Submission Type: **Public**

Wireless Coverage Solutions (WCS) is a privately owned Australian company supplying world-class Distributed Antenna Systems (DAS) solutions across all types of environments. We consult on Distributed Antenna Systems with building owners and technology managers to provide turnkey mobile coverage solutions utilising our in-house teams.

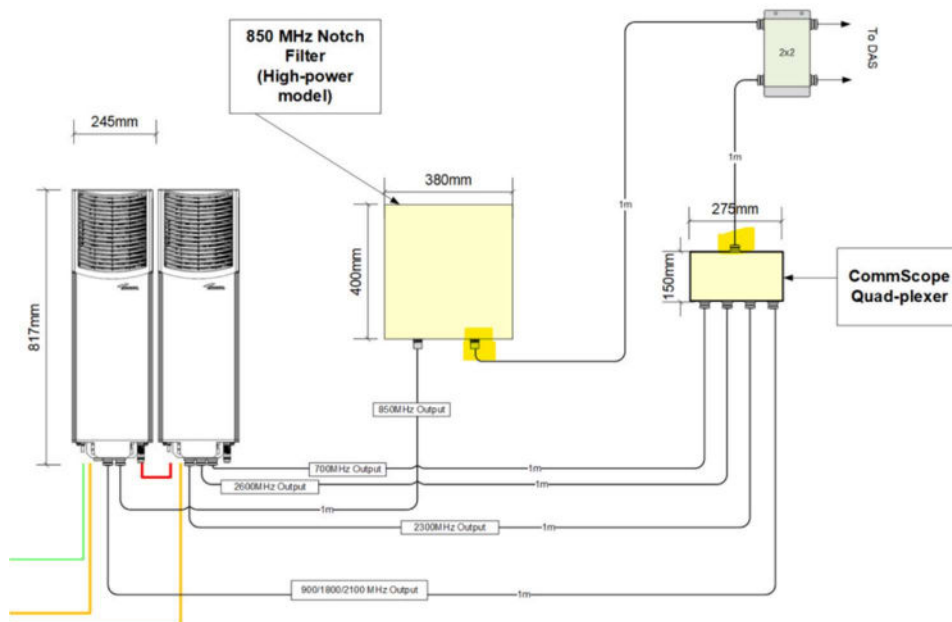
“For the purpose of PIM performance requirements on a Hybrid DAS each active remote unit will be viewed as if it is a ‘multi network combiner’ with the above passive DAS testing”

This conclusion is rational in nature given the shared nature of a Hybrid DAS remote unit, much like the shared/combined nature of the MNC output. This is where the application of DAS loss is critical to provide a relevant test. Knowing that a multi network combiner provides a loss of 6dB and the low loss nature of Hybrid segments the powers should be

adjusted accordingly to provide a test that provides a relative indication of performance based on how the system will be used

The test should be documented with a diagram (sample below) whereby the test is completed at the most forward location to the remote unit before any means of filtering/band-specific componentry would impact the tests.

Low Band Testing 700,850,900 to be completed at 2x34dBm (noting the 6dB sharing loss associated with an MNC) with a pass of -140dBc

Mid Band Testing 1800,2100,2600 to be completed at 2x37dBm (noting the 6dB sharing loss associated with an MNC) with a pass of -140dBc
